ORIGINAL MOUNT VERNON HIGH SCHOOL

CURTAINWALL/STOREFRONT SHOP DRAWINGS

VMO ARCHITECTS

PROJECT NUMBER:
24-323

BS5 ELEVATION BS5
E7 DRAWING SCALE
24x36: 1/2" = 1'-0"
11x17: 1/4" = 1'-0"

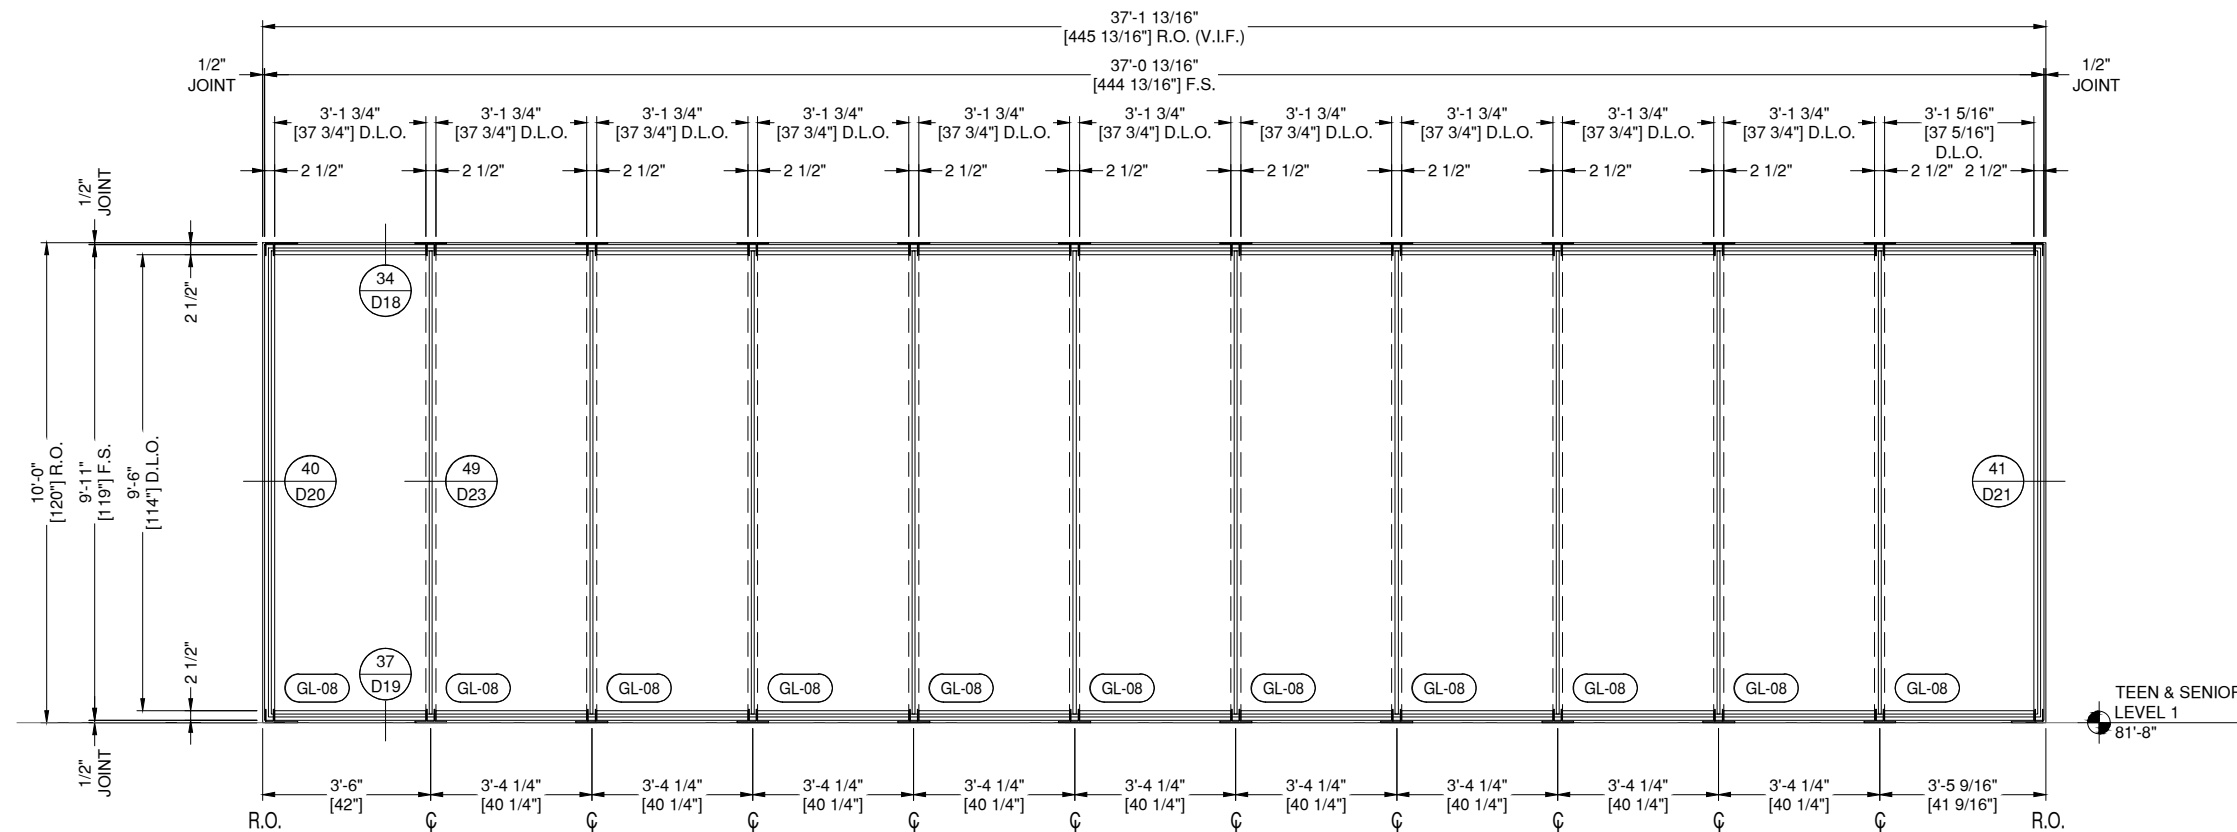
E.O.R. NOTE:
VERIFY EXPECTED LIVE LOAD
DEFLECTION AT THIS LOCATION

SHEET:
D19

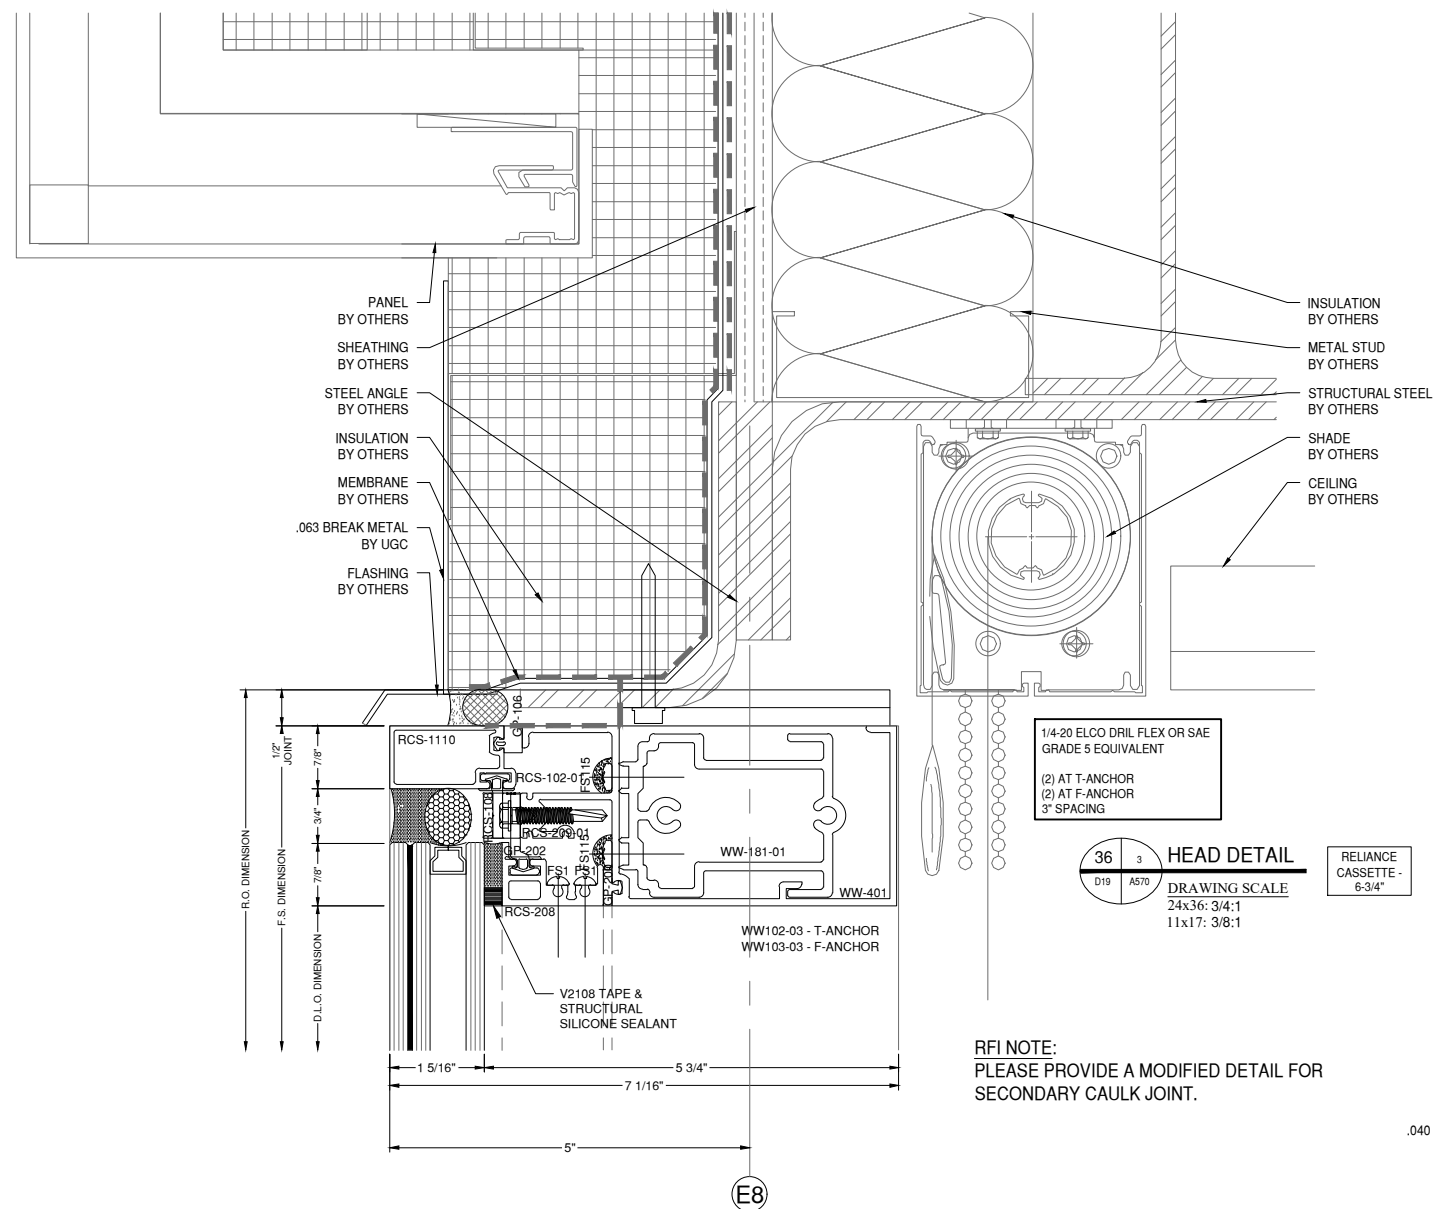
E.O.R. NOTE:
MODIFY F & T ANCHORS TO
ALLOW FOR MINIMUM 3/4"
DISTANCE FROM CENTER OF
FASTENER TO EDGE OF
ANCHOR

78A DOOR JAMB DETAIL
3000XT CENTER SET
WS-500TC
DRAWING SCALE
24x36: 3/4:1
11x17: 3/8:1

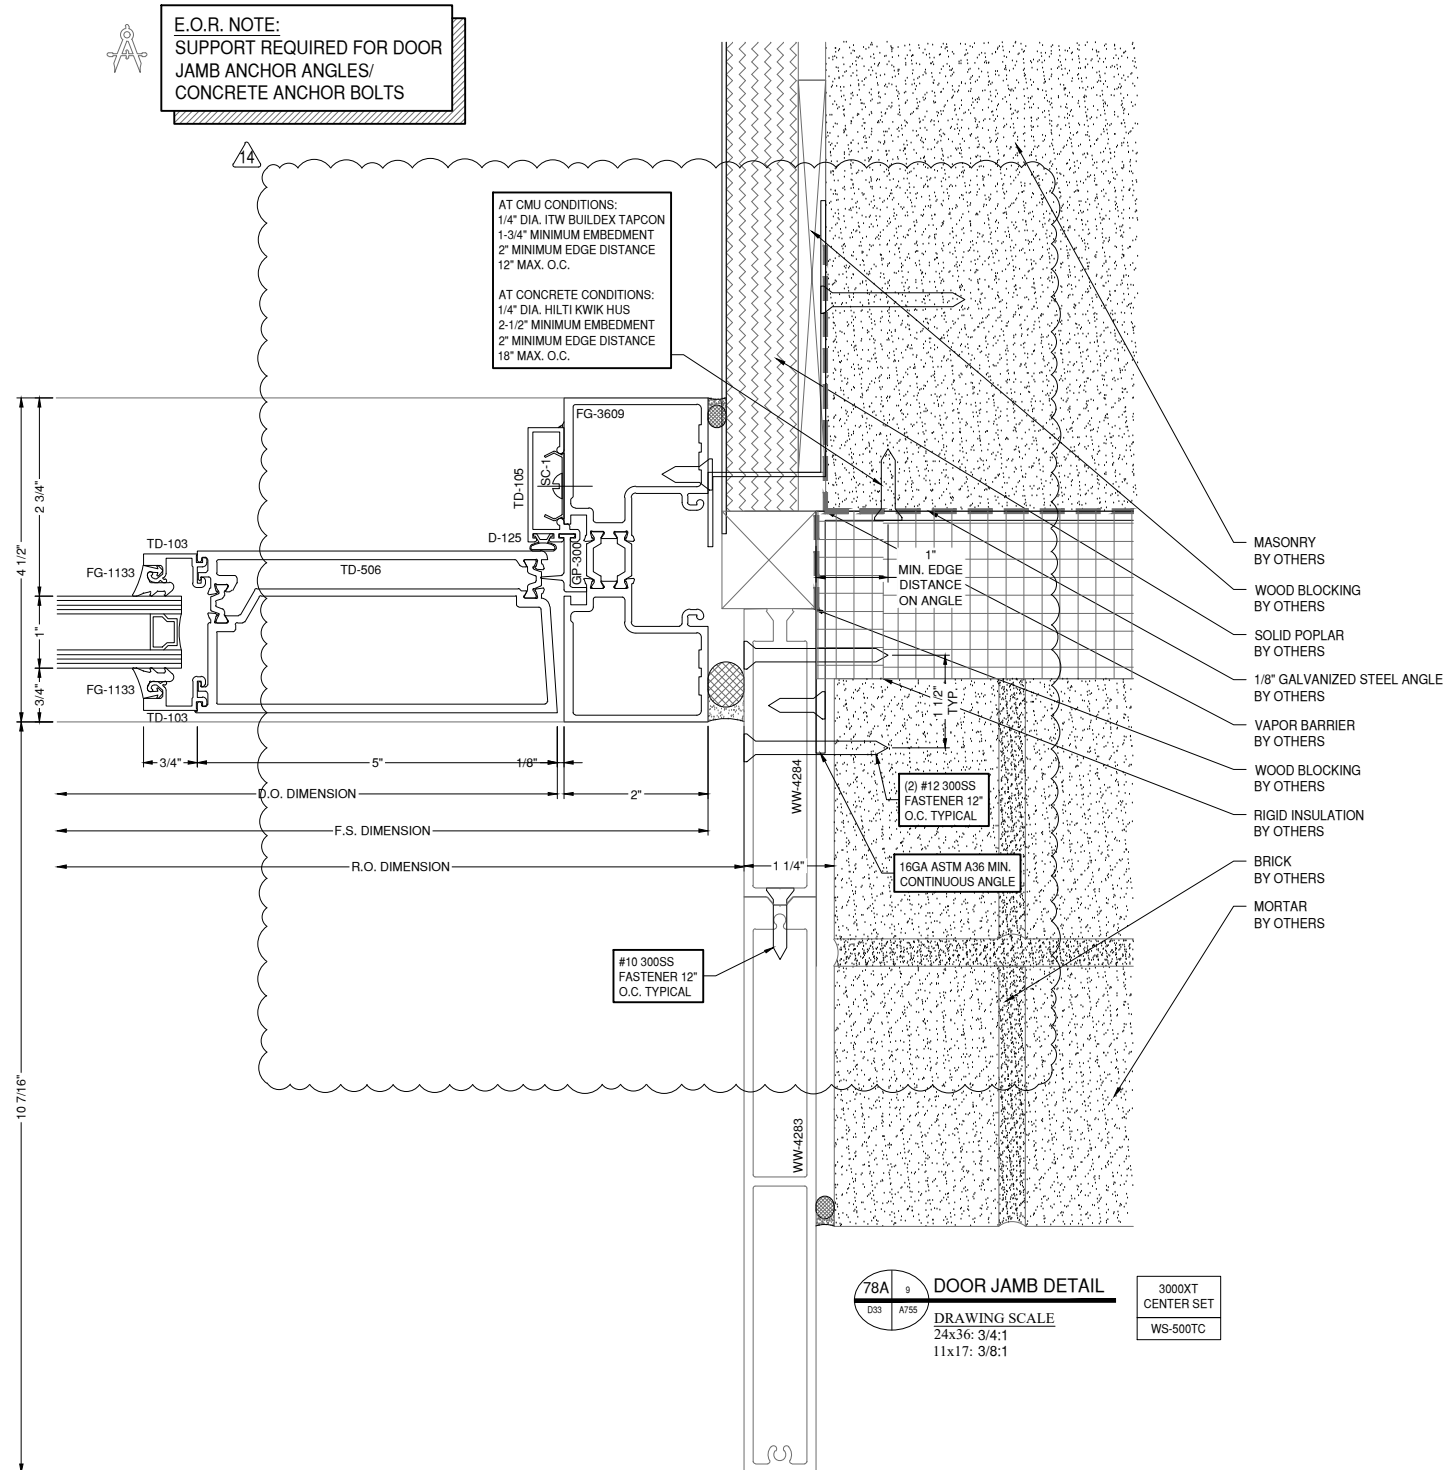
E.O.R. NOTE:
SUPPORT REQUIRED FOR DOOR
JAMB ANCHOR ANGLES/
CONCRETE ANCHOR BOLTS

2 1 ANCHOR DETAIL
 AF2 AS02
 DRAWING SCALE
 24x36: N.T.S.
 11x17: N.T.S.
 RELIANCE CASSETTE - 10-7/8"

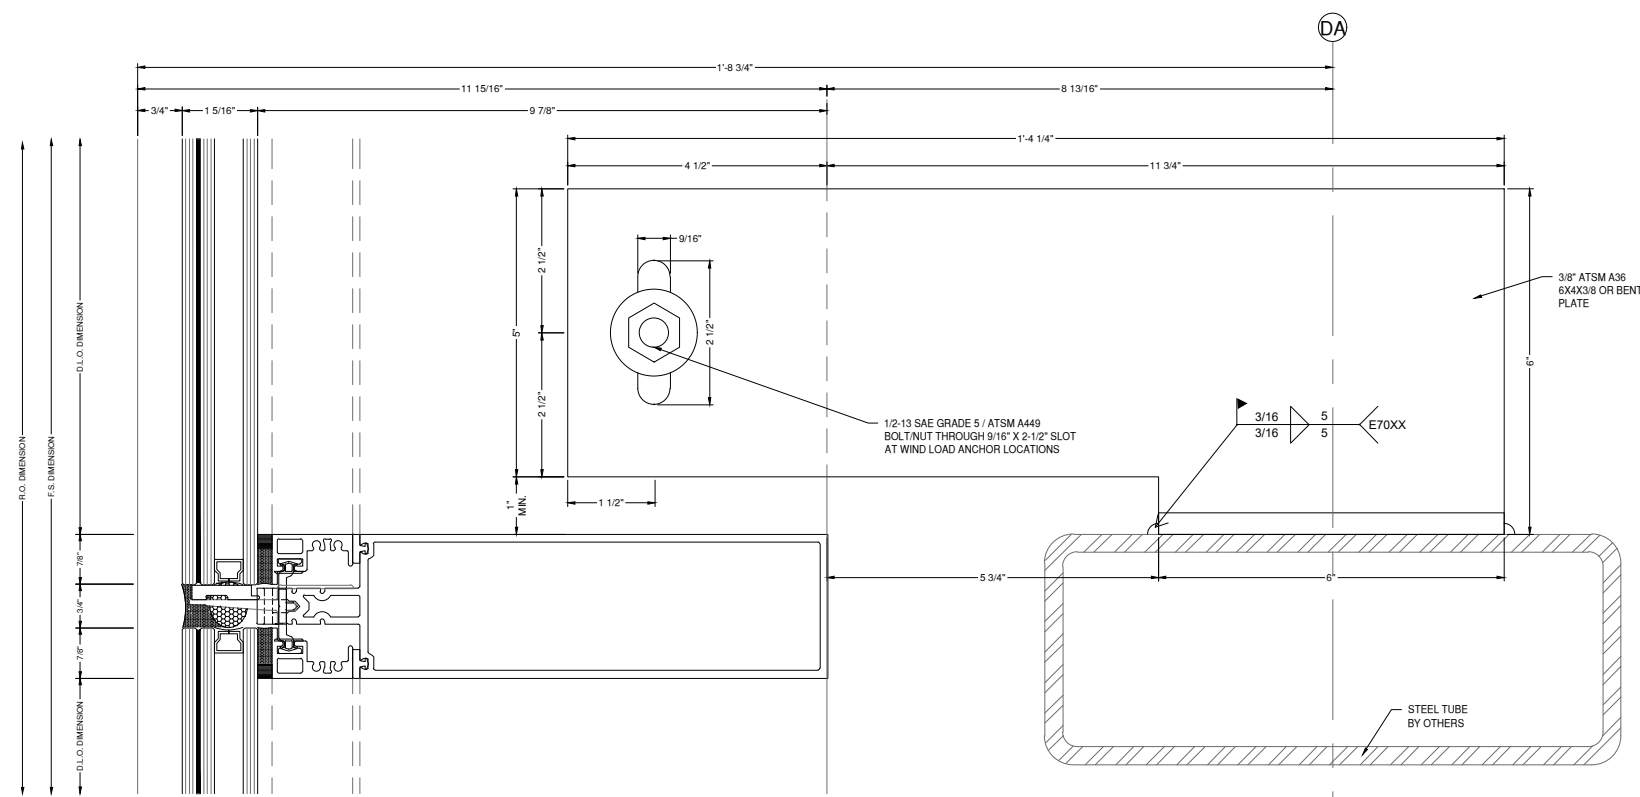
INSTALLER NOTE:
VERIFY LOCATION WHERE THE
HSS10x4x3/8 STEEL BEAM
TERMINATES. THE EXTENDED LEG
OF THE ANCHOR AT THIS JAMB
MAY BE MODIFIED IF THE STEEL
BEAM IS CLOSER TO THE JAMB.

NOTE:
PLEASE COORDINATE THE CONNECTION
AT THE CORNER. I BEAMS AND TUBE STEEL
MAY NEED TO BE MODIFIED IN ORDER FOR
THE CLIPS TO A MOUNTING SURFACE.
